UNITED STATES  
NUCLEAR REGULATORY COMMISSION  
WASHINGTON, D. C. 20555

Docket No. 50-461

FACILITY: Clinton Power Station

SUBJECT: SUMMARY OF MEETING WITH ILLINOIS POWER COMPANY RELATED  
TO FIRE PROTECTION FOR CLINTON POWER STATION

DETAIL A21-1070-18

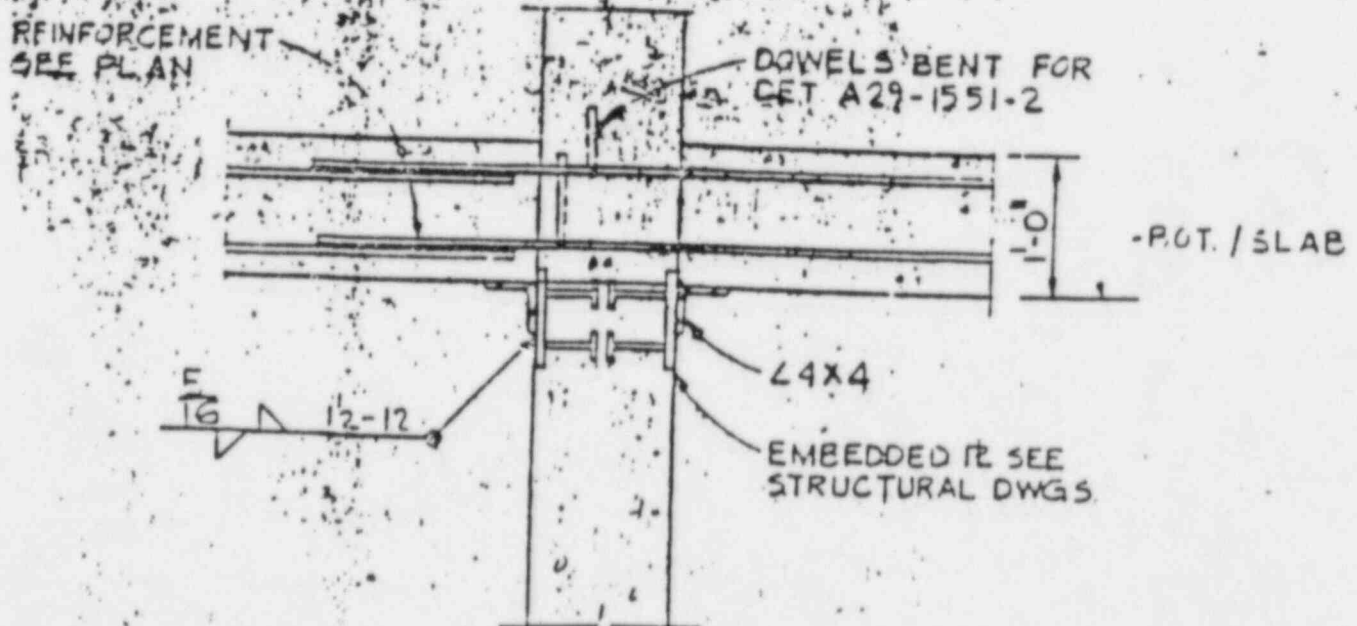
- 23) Provide justification why the unprotected steel in the Diesel Generator Day Tank Rooms does not derate the fire barriers.

The L4x4 member in the Diesel Generator Day Tank Room, as shown on the following Detail A21-1070-18, provided temporary support for the wet concrete of the roof slab and adds shear resistance to the joint detail. The angle is welded to an embedment plate similar to other attachments to concrete firewalls. This angle is not required to maintain the integrity of the roof slab.

Additionally, the concrete wall which has the embedment plate for the angle is continuous and has no gaps and therefore provides a continuous fire barrier.
